Access Compliance Report

Public Rights-of-Way

(Curb Ramps)

Intersection ID: 10024489	Main Street: CROWN_CRESCENT_CT	Cross Street: N/A	Location: SW
ADA ID: 6F001049C214	Ramp Type: PerpDiag	Initial Pass/Fail: Fail	Overall Compliance: No
Severity Score: 33.75			
Codes/Mitigation Info/Possible Solution		Field Measurements/Component Compliance

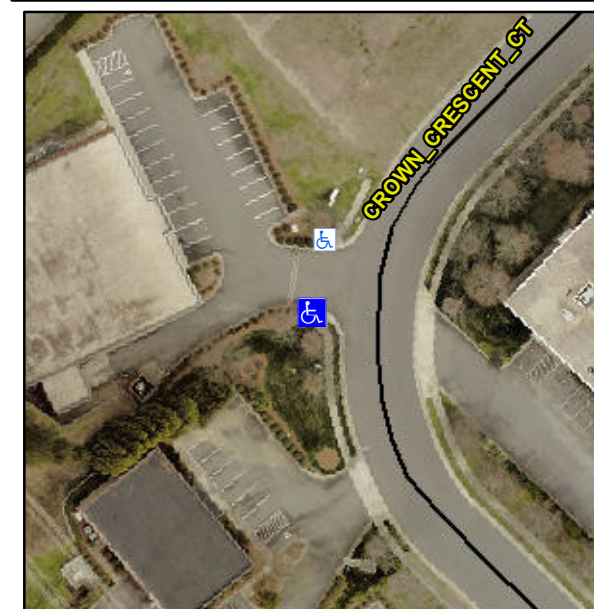
Not Found, R304.5.1, R304.5.3

Compliance	Description	Data	Compliance	Description	Data
N/A	Ramp Length (in)	48.0	Yes	Ramp Slope (%)	5.5
No	Ramp Width (in)	42.0	No	Ramp XSlope (%)	12.2
N/A	Flare Type LT	N/A	N/A	Flare Type RT	N/A
N/A	Flare Slope LT (%)	N/A	N/A	Flare Slope RT (%)	N/A
N/A	Flare Traversable LT?	N/A	N/A	Flare Traversable RT?	N/A
N/A	Landing Length (in)	N/A	N/A	DWS Provided?	N/A
N/A	Landing Width (in)	N/A	N/A	DWS Contrast?	N/A
N/A	Landing Slope (%)	N/A	N/A	DWS Length (in)	N/A
N/A	Landing X Slope (%)	N/A	N/A	DWS Full Width?	N/A
N/A	Landing Curb? (Y/N)	N/A	N/A	DWS Offset (in)	N/A
N/A	Shared Landing?	N/A			
N/A	Gutter Ponding?	N/A	N/A	Gutter Slope (%)	N/A
N/A	Gutter Lip Ht (in)	N/A	N/A	Gutter X Slope (%)	N/A
N/A	Painted X Walk1?	No	N/A	Painted X Walk2?	No
	X Walk 1 Direction	To E		X Walk 2 Direction	To N
N/A	X Walk 1 Width (in)	N/A	N/A	X Walk 2 Width (in)	N/A
	X Walk 1 Slope (%)	12.4		X Walk 2 Slope (%)	2.1
	X Walk 1 X Slope (%)	3.5		X Walk 2 X Slope (%)	13.9

Remove & Replace Curb Ramp With Two New Directional Ramps or Equivalent.
